ATTACHMENT 1

REVISED PROPOSED CATAWBA TECHNICAL SPECIFICATIONS CHANGES

ATTACHMENT 2

REVISED JUSTIFICATION AND SAFETY ANALYSIS

FIGURE 1

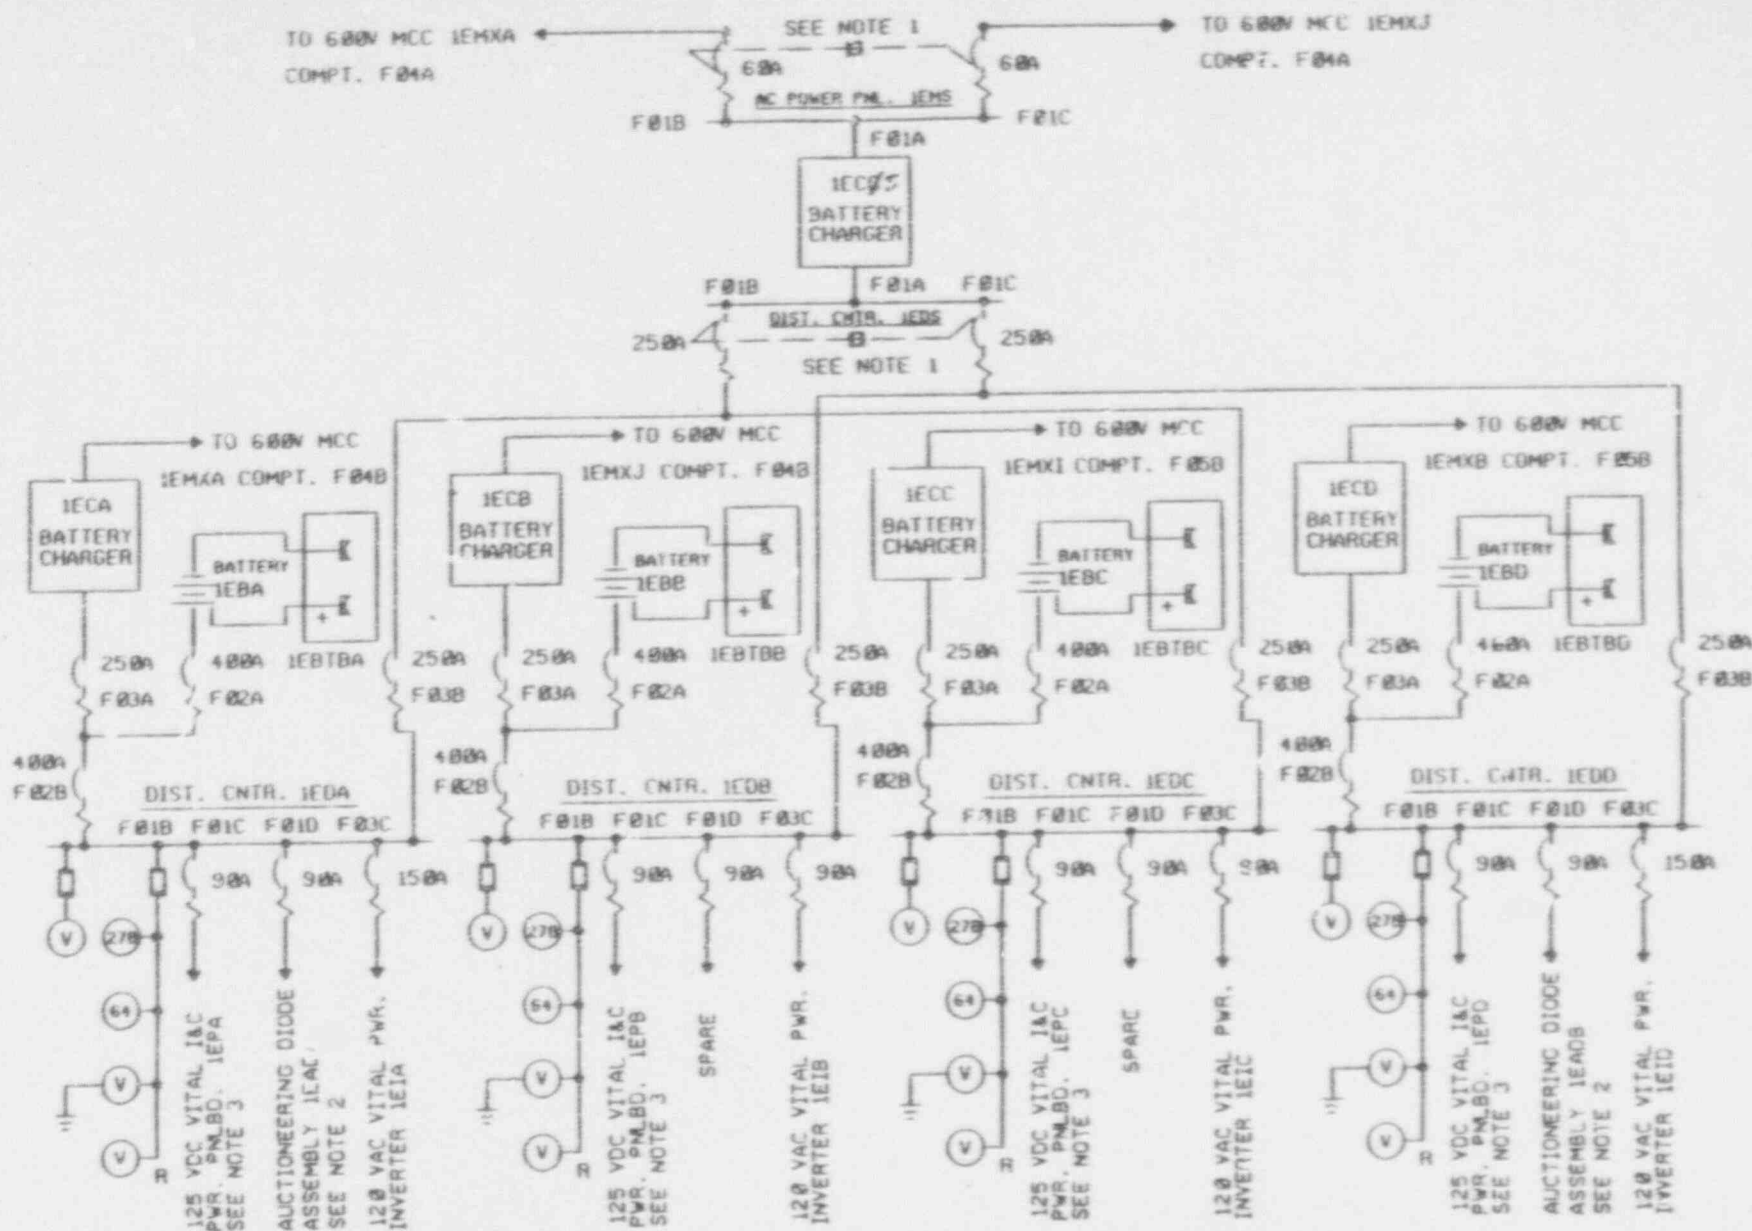
Figure 1 depicts the DC portion of the vital I&C power system.

Because of the design of the DC portion of the vital I&C power system at Catawba, deleting the shutdown requirement from Surveillance Requirement 4.8.2.1.1.d will have no significant effect upon nuclear safety. Due to Catawba's ability to cross-tie a vital bus to an alternate battery as indicated in the above discussion and as illustrated in Figure 1, the affected channel will remain battery-backed while its battery is taken out of service in order to perform the service test. When a service test is being performed on a particular battery, the associated battery charger is removed from service and the standby charger (ECS) is connected to the affected distribution center. Therefore, both a battery and two battery chargers remain available to supply the cross-tied channels during the test.
